EASTONVILLE ROAD FROM LONDONDERRY DRIVE TO REX ROAD SEGMENT 1 IMPROVEMENTS STATIONING 14+19.69 - 47+66.51

OVERALL SHEET INDEX	
SEGMENT 1	SHEETS 1-42
SEGMENT 2	SHEETS 43-96

EDARP FILING NO. CDR2321

SHEET
PD.13 **30**

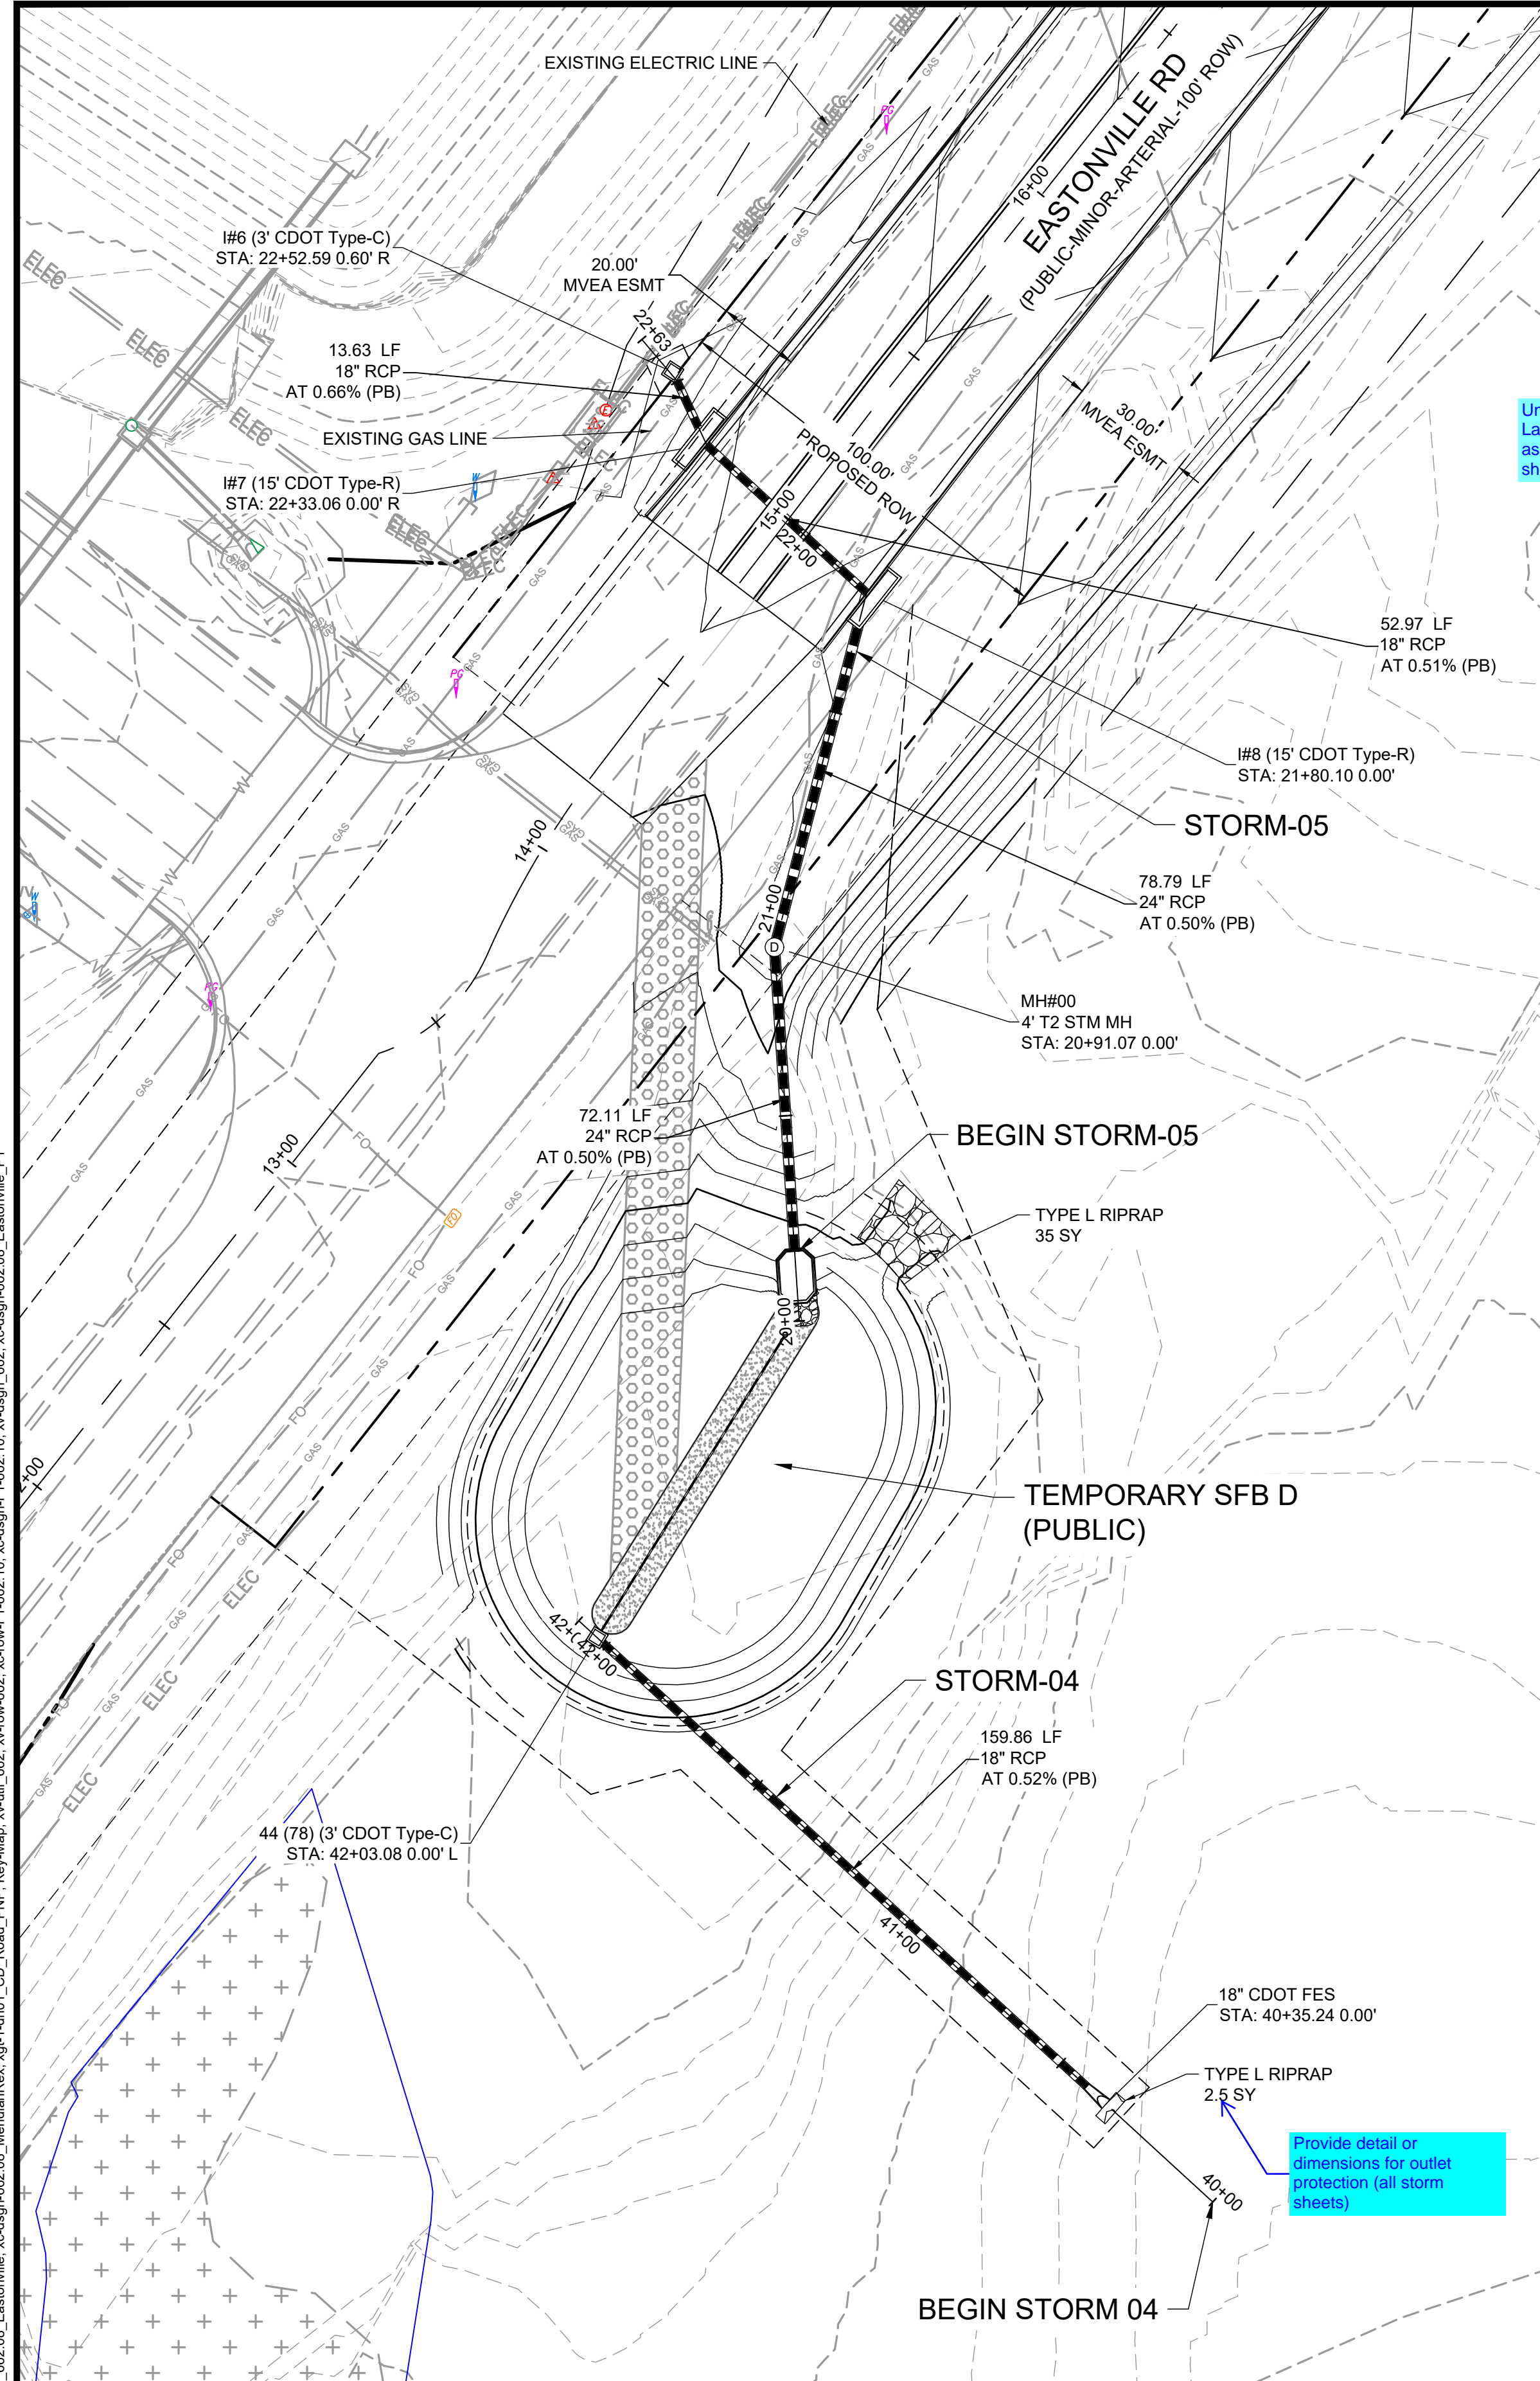
Is this detail rotated 90deg or something? I don't understand a horizontal orifice plate...please clarify.

Unresolved previous comment: I don't see a detail for this plate anywhere

clarify that this needs to be slotted pipe.

Clarification on underdrain piping: perforated pipe has holes, while slotted pipe has more like cuts along its circumference. MHFD recommends the use of slotted pipe. See Table SF-2 in MHFD Detail T-6 for slot dimensions and req's.

SHEET
STM.1 31

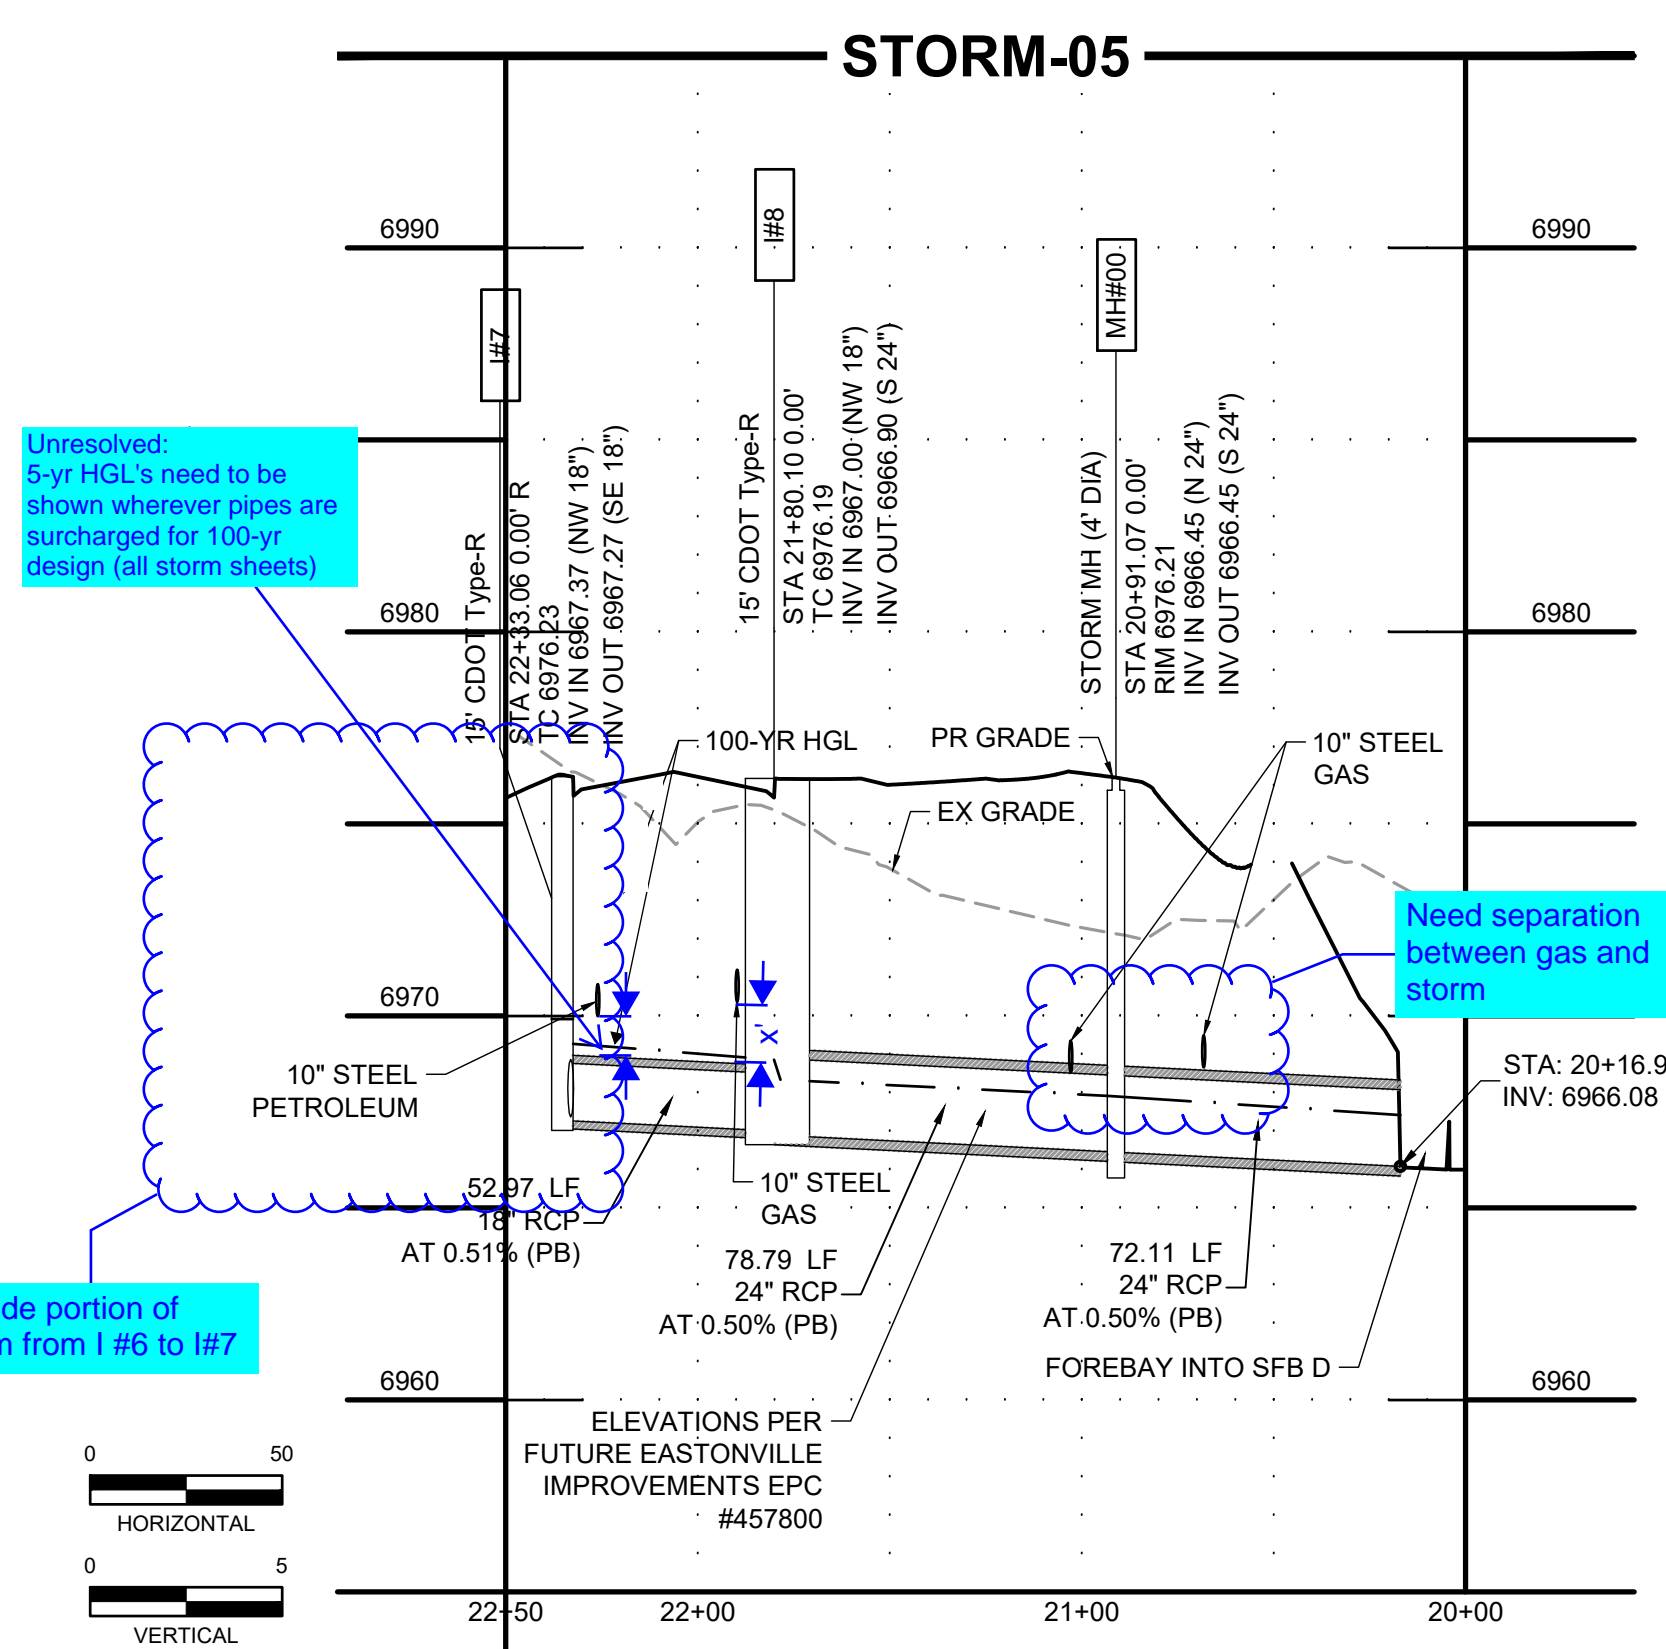
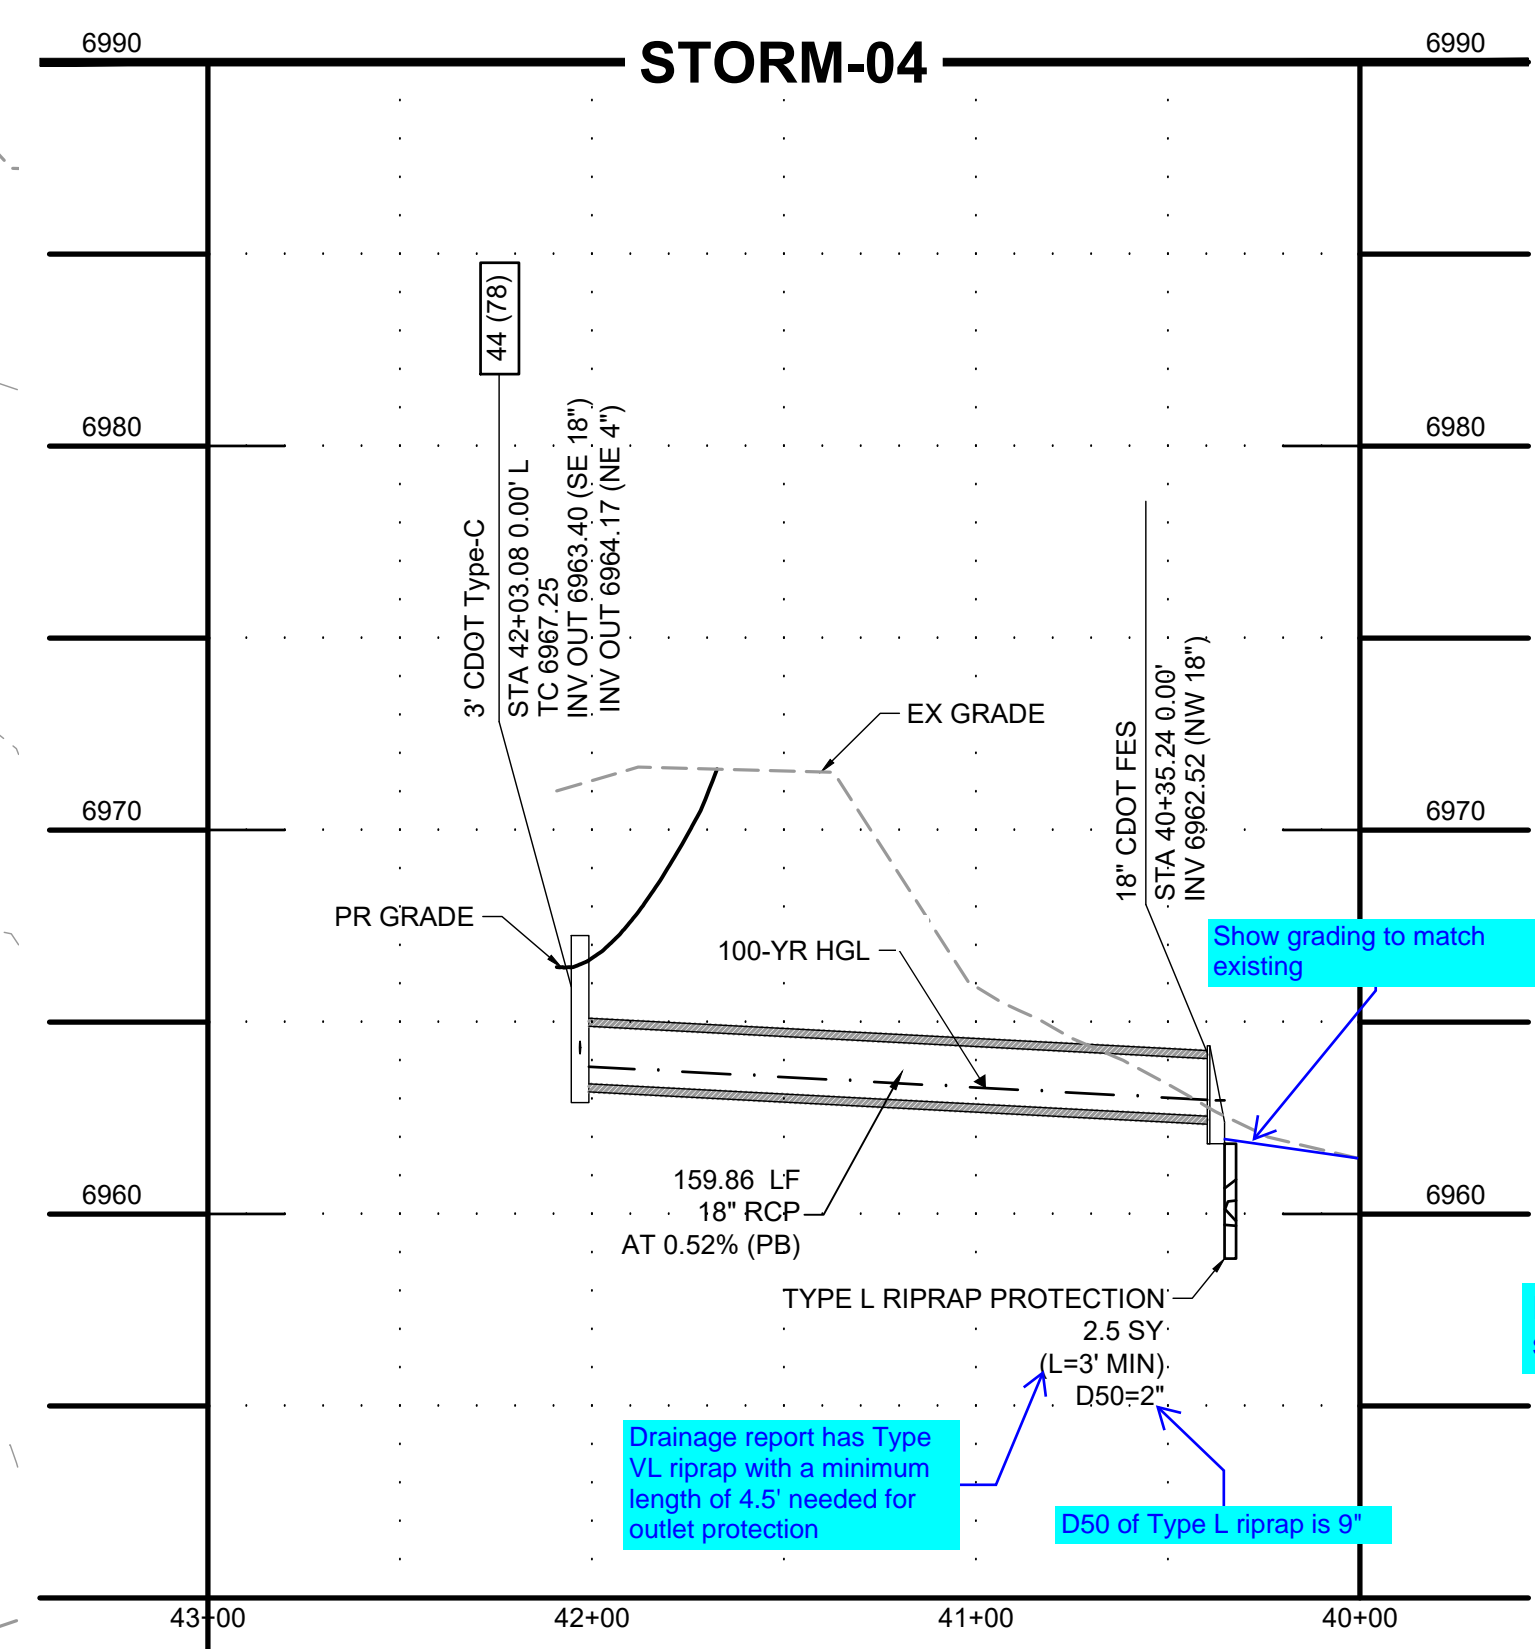
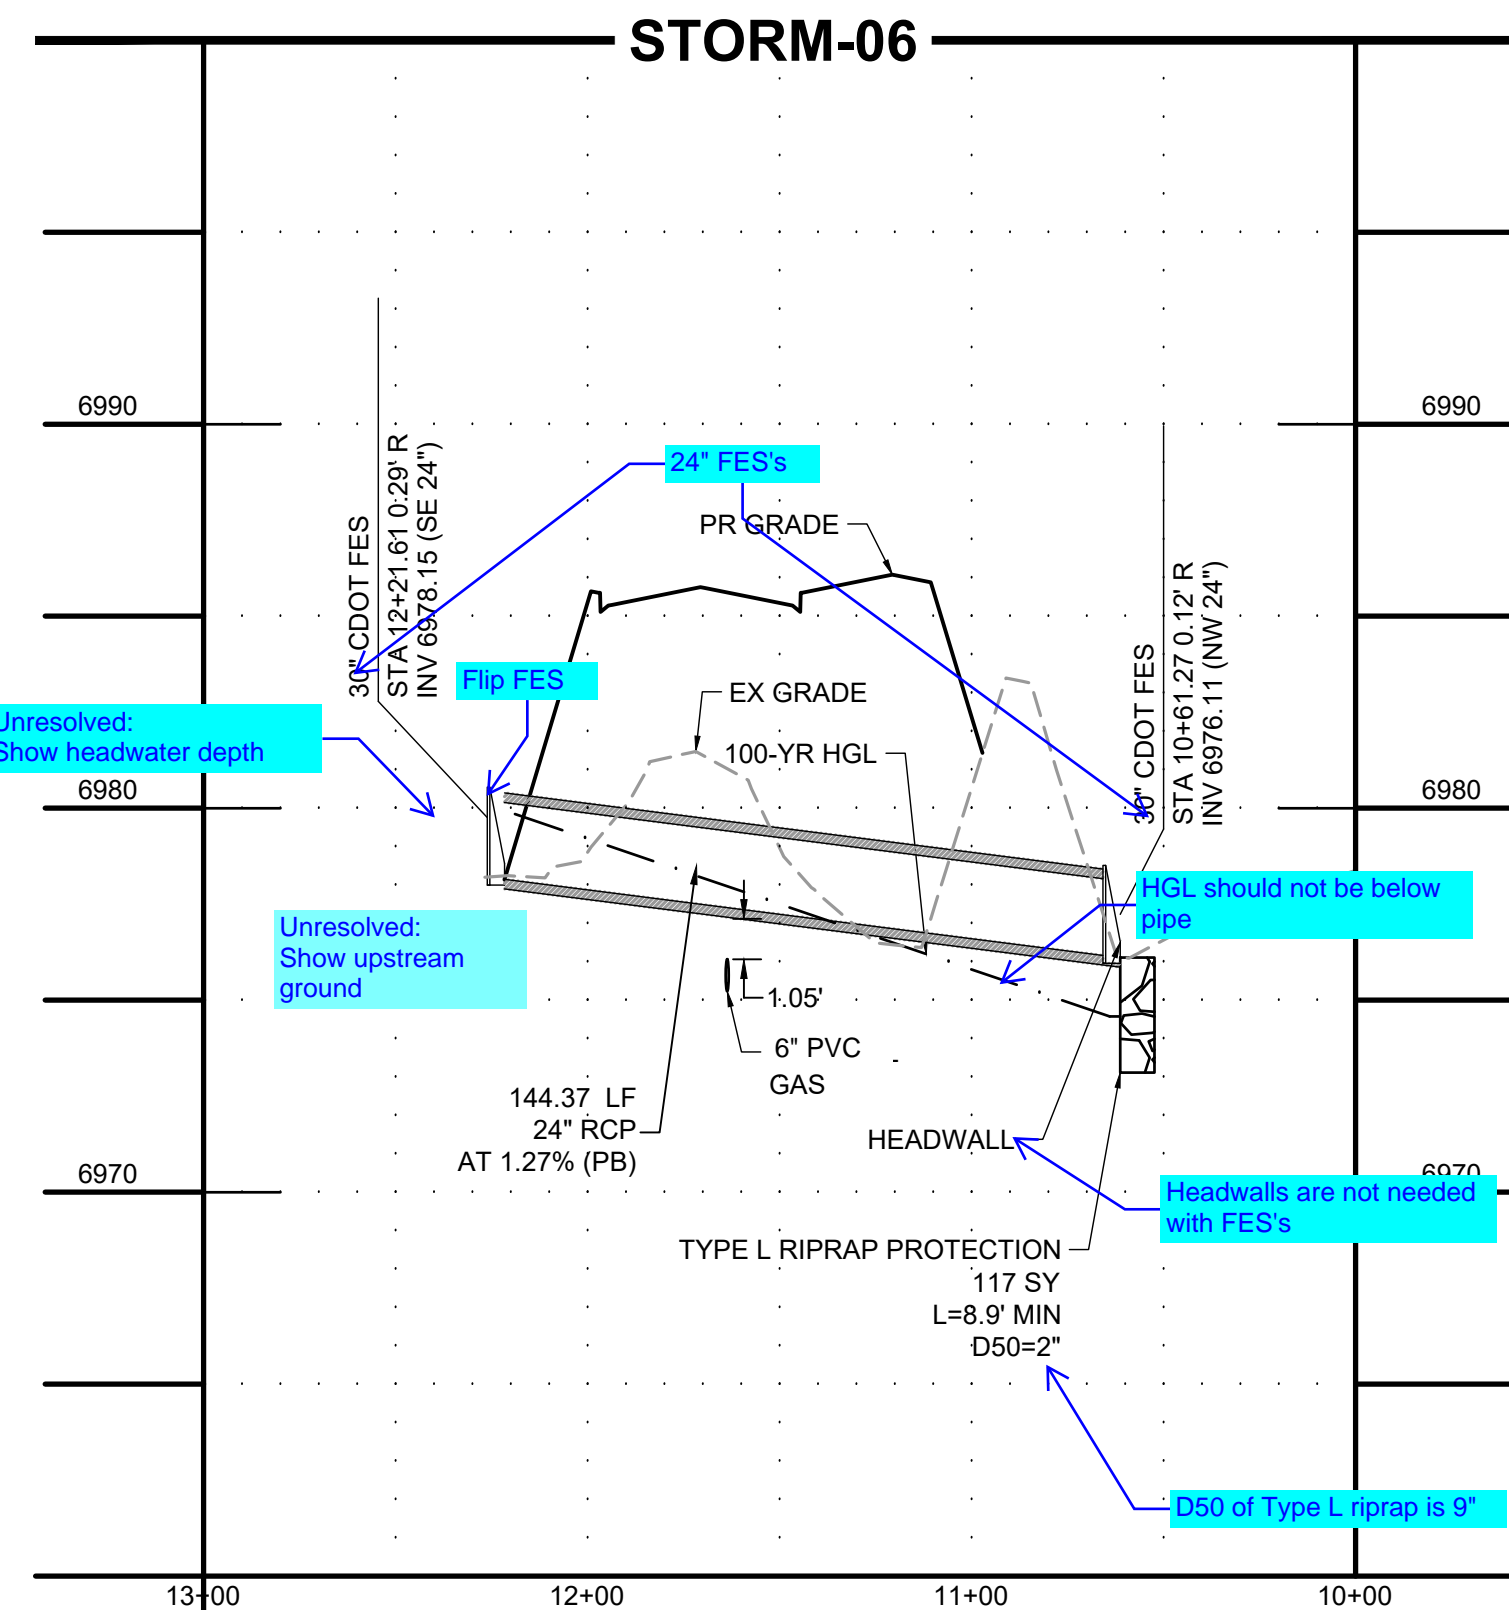
Unresolved:
Label all storm infrastructure
as public or private (All storm
sheets)

Unresolved:
5-yr HGL's need to be
shown wherever pipes are
surcharged for 100-yr
design (all storm sheets)

Provide detail or
dimensions for outlet
protection (all storm
sheets)
